RELEASE FOR  
CONSTRUCTION  
APPROVED ON PLANS REVIEW  
DATE: 5/23/22  
LET'S SUMMIT. MISSOURI

RE: P210272 - Juneau Townhomes - Osage

**General Truss Engineering Criteria & Design Loads (Individual Truss Design Drawings Show Special Loading Conditions):**

| P210272 | A2    | Roof Special Girder | 2   | 2   | Job Reference (optional) |           |

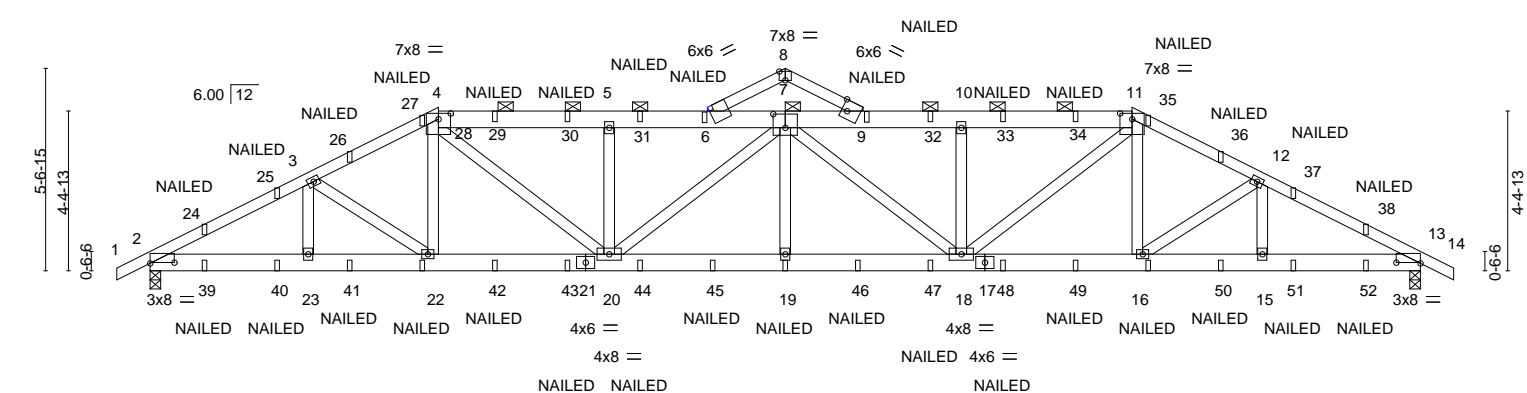
Premier Building Supply (Springhill, KS), Spring Hills, KS - 66083, 8.530 s Dec 6 2021 MiTek Industries, Inc. Mon May 23 09:27:03 2022 Page 1  
 ID:DUjzAB0GCWwOJpyMsoTzILz3uah-32lk?Ehr8Ffh9osYBOrufjoBmZKdofB5rv?rzDfb6  
 -0-11-0 4-4-4 7-11-5 12-7-13 15-4-4 17-6-0 19-7-12 22-4-3 27-0-11 30-7-12 35-0-0 35-11-0  
 0-11-0 4-4-4 3-7-1 4-8-7 2-8-7 2-1-12 2-1-12 2-8-7 4-8-7 3-7-1 4-4-4 0-11-0  
 REPAIR: ONE PLY NOTCHED 0-1-8 AT JOINT 6.  
 Scale: 3/16"=1'

# NO REPAIR REQUIRED.

LUMBER AND CONNECTOR PLATES (SHOWN DASHED) TO BE CUT CLEANLY AND ACCURATELY AND THE REMAINING PLATE(S) MUST BE FULLY EMBEDDED AND UNDISTURBED.

| P210272 | A13   | Common Supported Gable | 2   | 1   | Job Reference (optional) |           |

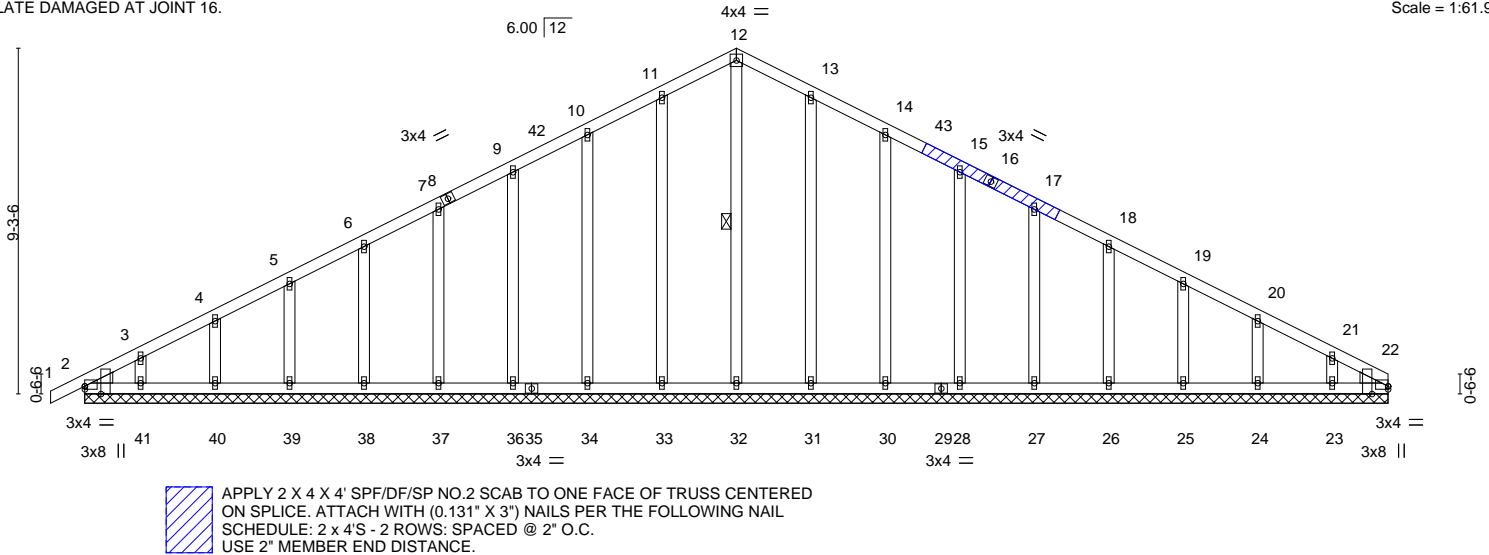
REPAIR:  
PLATE DAMAGED AT JOINT 16.

| P210272 | A19   | Roof Special | 2   | 1   | Job Reference (optional) |           |

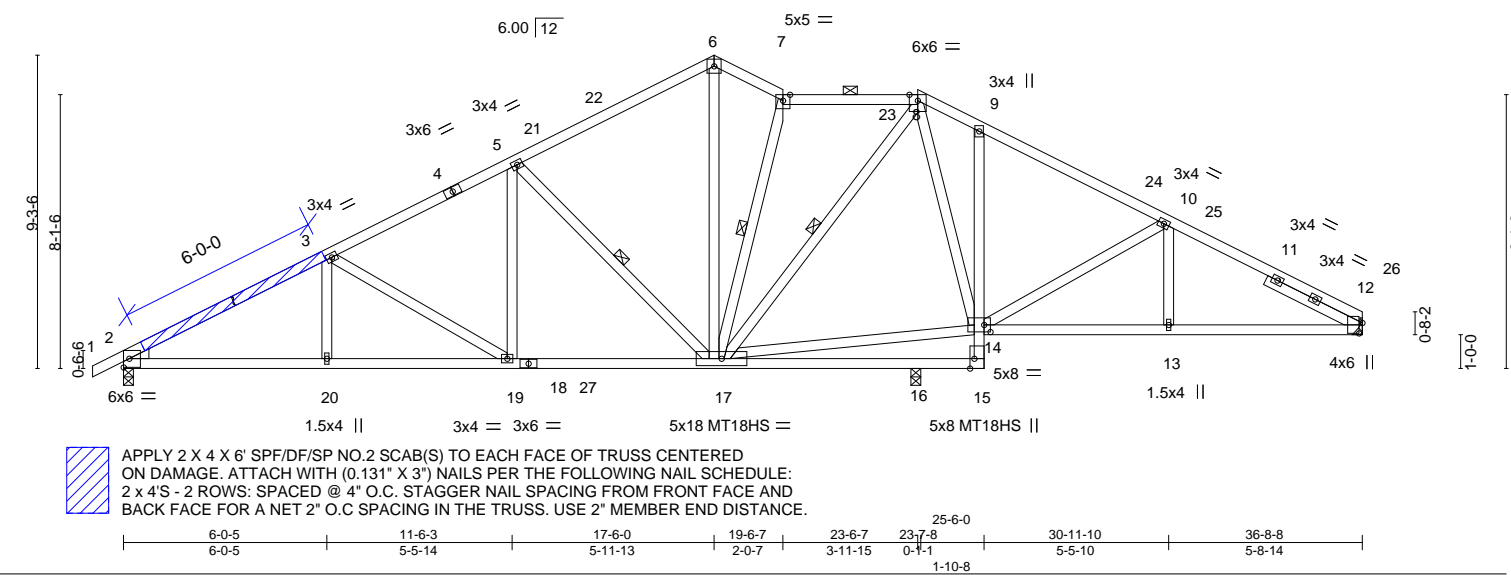
REPAIR:  
BREAK IN MEMBER 2-3 LOCATED AT MIDPOINT.

| P210272 | A21   | Roof Special | 4   | 1   | Job Reference (optional) |           |

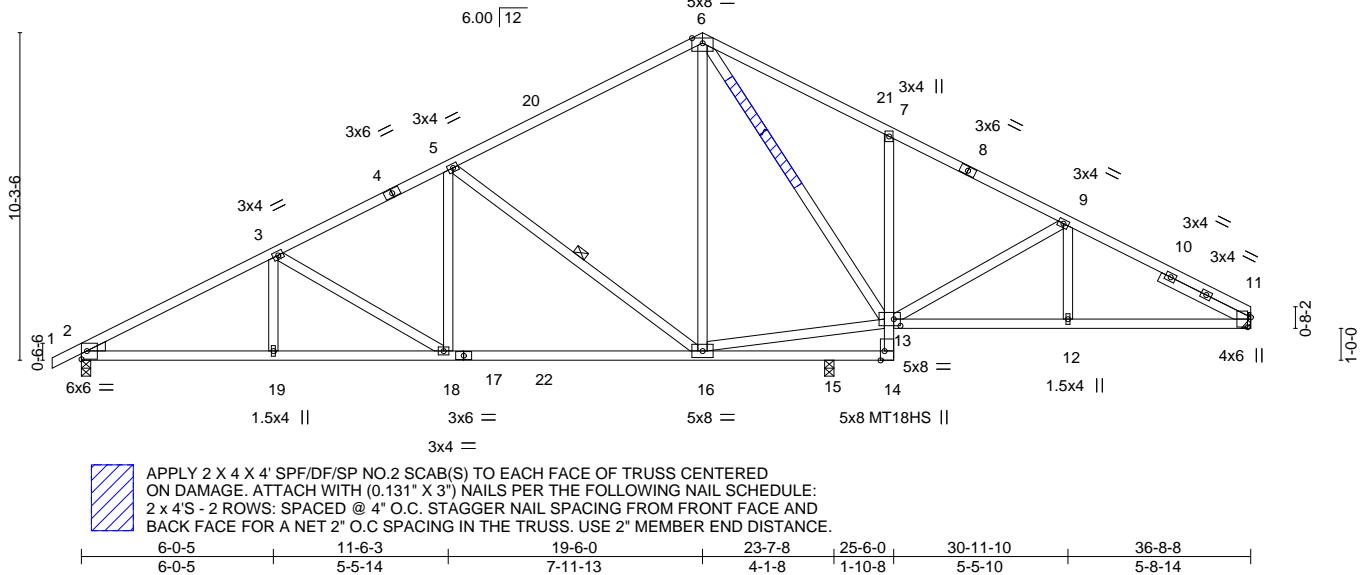
REPAIR:  
BREAK IN MEMBER 6-13 LOCATED 3-0-0 FROM JOINT 6.

| P210272 | HG2   | GABLE      | 4   | 1   | 152101486                |

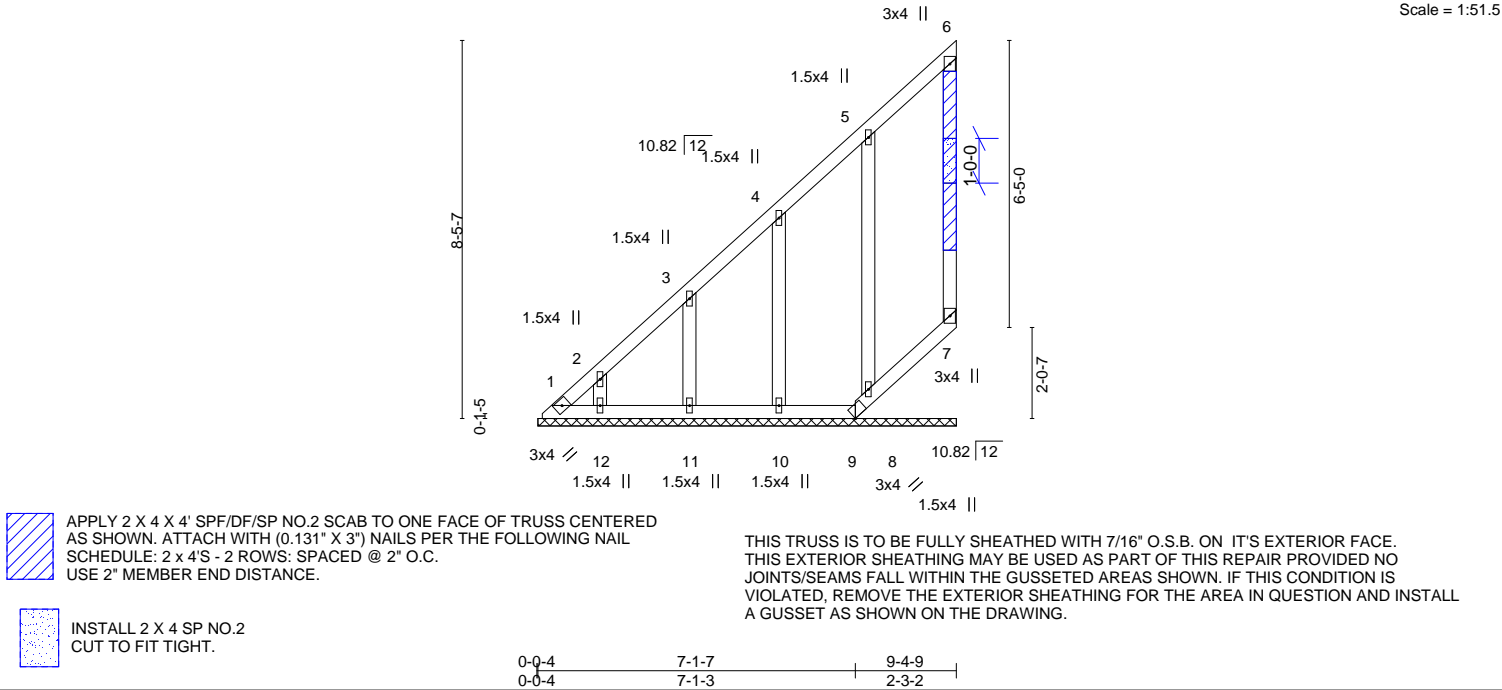
REPAIR:

REPLACE DAMAGED 1-0-0 SECTION OF WEB 6-7 AS SHOWN.
